# Service Information Letter

Letter No. A-110B

**Issue Date: Dec. 20, 2004**

# RECOMMENDED SERVICE/INSPECTION FOR MODEL 91E93-1 & 91E92-1 HEATER FUEL PUMP

# FIGURE 1

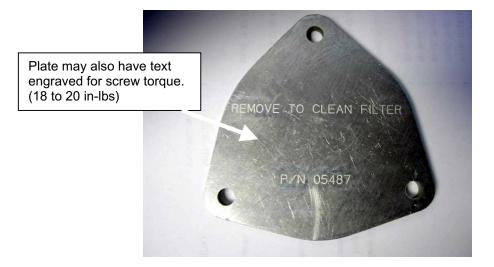
Pumps built with the affected serial number tags had kit components inadvertently left out at the factory. Clarification of identification procedure. Addition of photo of new cover plate to aid identification.

3. If you are unsure of either the serial number, data plate or previous compliance, inspect the end filter access cover, part number 05487 to determine if it is correct. If the cover is identical to the one shown in Figure 1 proceed to Step 5 below. If the cover is not identical to the cover in Figure 1 continue with these instructions.

- 4. If the cover is not identical to the cover in Figure 1 proceed to Step 3 of PART II found below.
- 5. Make an appropriate logbook entry of compliance with PART I of this SIL.

FIGURE 3

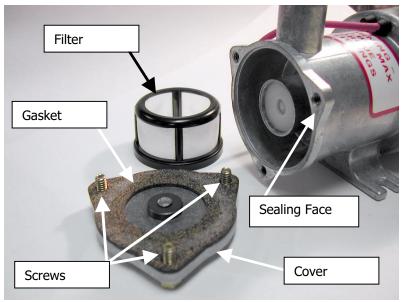
- 4. If signs of fuel leakage are found complete the following steps.
  - a. Remove fuel pump(s) from aircraft in accordance with the approved aircraft maintenance instructions.
  - b. Remove and discard fuel pump filter cover mounting screws, cover gasket, filter, and filter cover (see Figure 2).
  - c. Inspect the sealing surface of the fuel pump for surface abnormalities such as nicks, gouges, or warpage. If such abnormalities are found and cannot be corrected the fuel pump should be replaced.

- d. Install new filter, gasket, filter cover, and screws. These components are available in Kelly Aerospace Service Kit PN AK91E93. (NOTE... filter cover found in kit AK91E93 is fabricated from flat sheet stock and will not have surface relief feature on one side or small magnet on opposite side as depicted in Figure 3). Torque each screw in a sequential, progressive, fashion to 18-20 inch-lbs.
- e. Using permanent ink write the date of completion of this service activity on the pump ID tag in the SN field.
- f. Install the fuel pump(s) in accordance with the approved aircraft maintenance instructions.
